The Commission has issued the enclosed Amendment No. 23 to Facility License No. DPR-5 for the Indian Point Station Unit No. 1 and Amendment No. 48 to Facility License No. DPR-26 for the Indian Point Nuclear Generating Plant Unit No. 2. These amendments consist of changes to the Appendix B Technical Specifications in response to your requests dated April 20, 1977, April 25, 1977, December 30, 1977, March 22, 1978, April 24, 1978 and May 10, 1978.

These amendments revise and restructure the administrative controls section (Section 5) of the Environmental Technical Specifications, which has been reissued in its entirety with this amendment.

ATTACHMENT TO LICENSE AMENDMENT NOS. 23 AND 48

5,0 ADMINISTRATIVE CONTROLS

ORGANIZATION CHART
FIG. 51-1

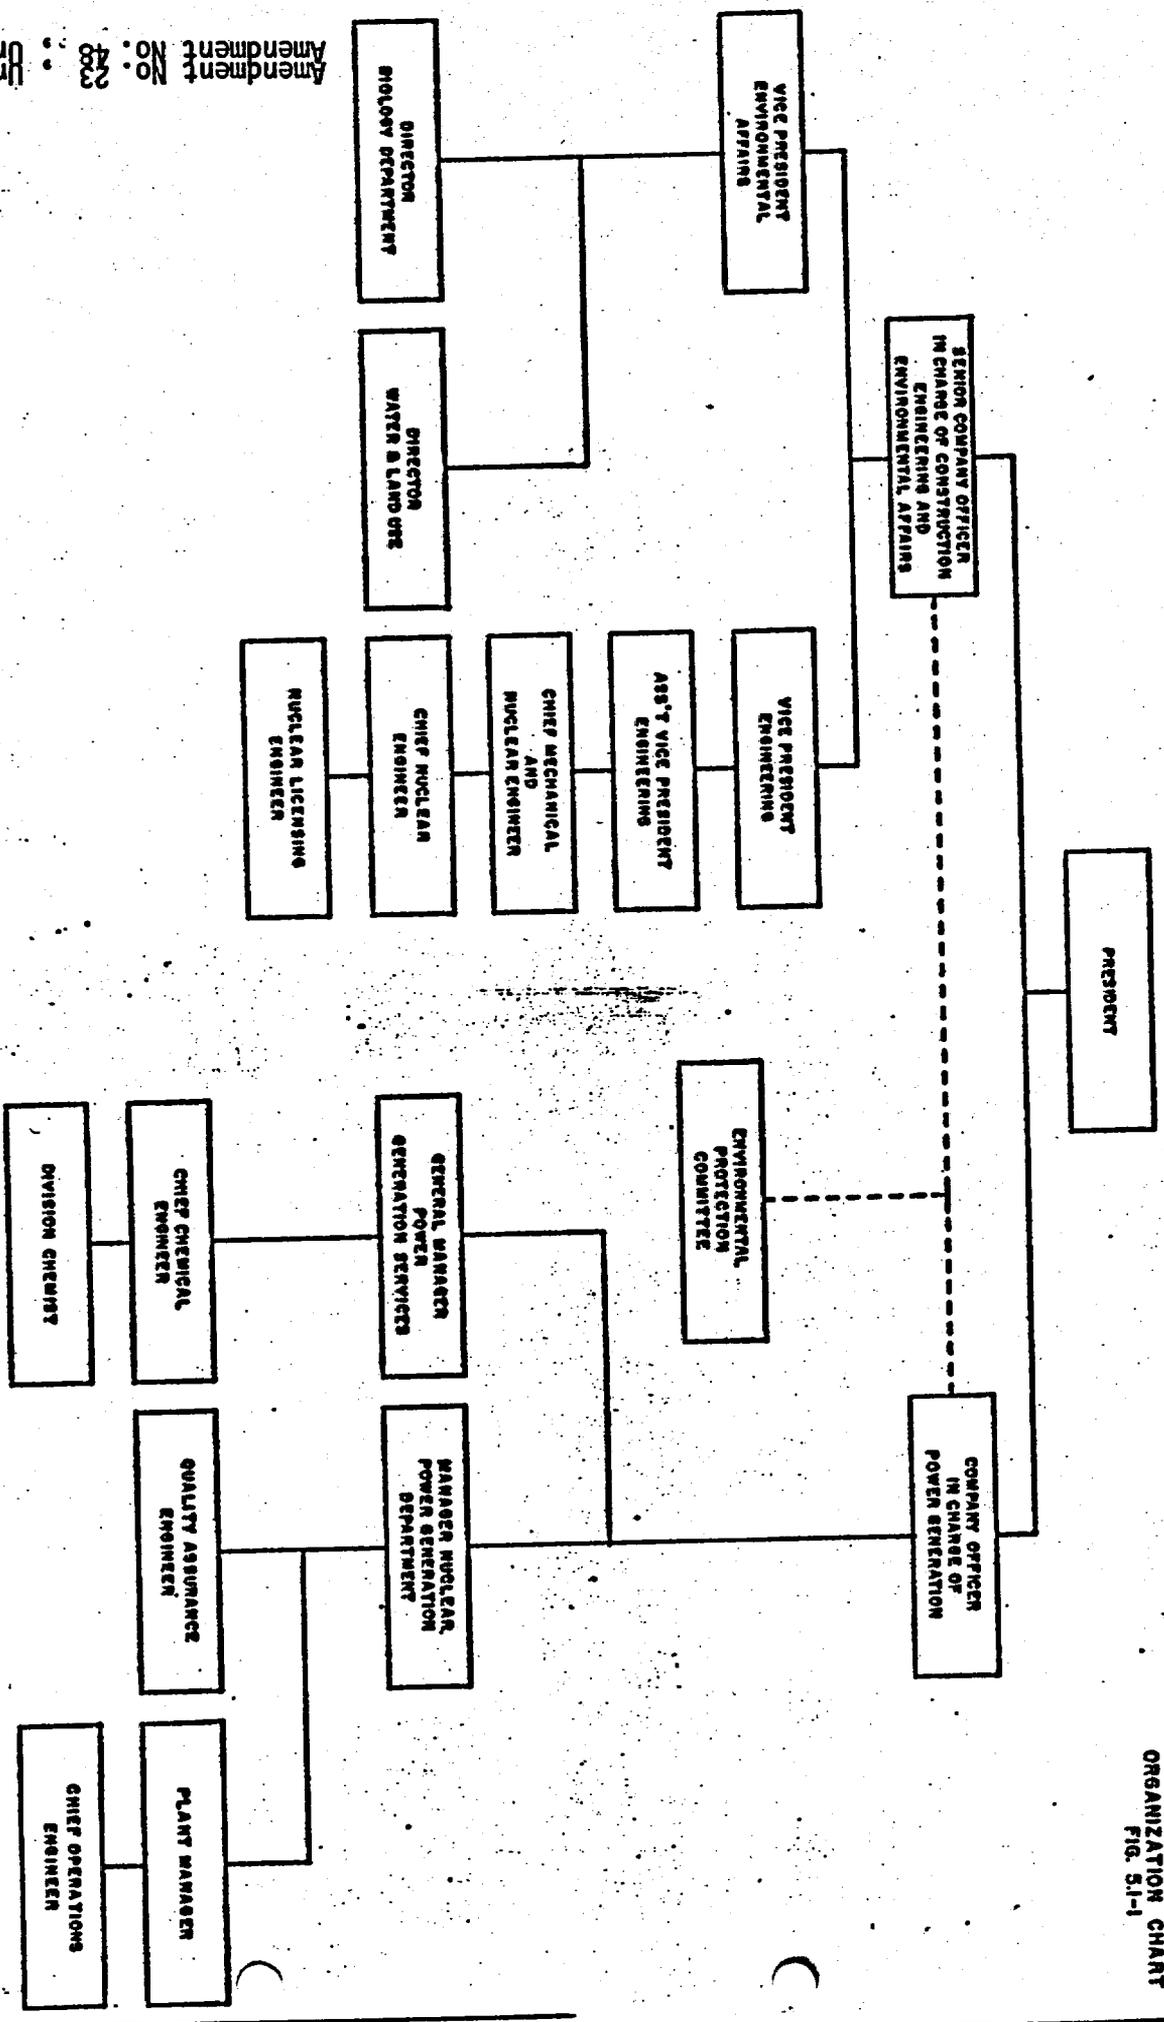
We have evaluated the potential for environmental impact of operation of these facilities in accordance with the enclosed amendments. These amendments apply to administrative details and include changes to the organization chart, and clarification of the role of the Environmental Protection Committee (EPC) to encompass only non-radiological programs and annual review of these programs.

- 5.1 Organization and Responsibilities, Review and Audit, Environmental Protection Committee Organization
- 5.1.1 Organization and Responsibilities
- 5.1.1.1 The ultimate responsibility for the implementation of the Environmental Technical Specifications shall reside with the corporate officers of Consolidated Edison Company of New York, Inc. The corporate and Station level organization chart is shown in Figure 5.1-1.
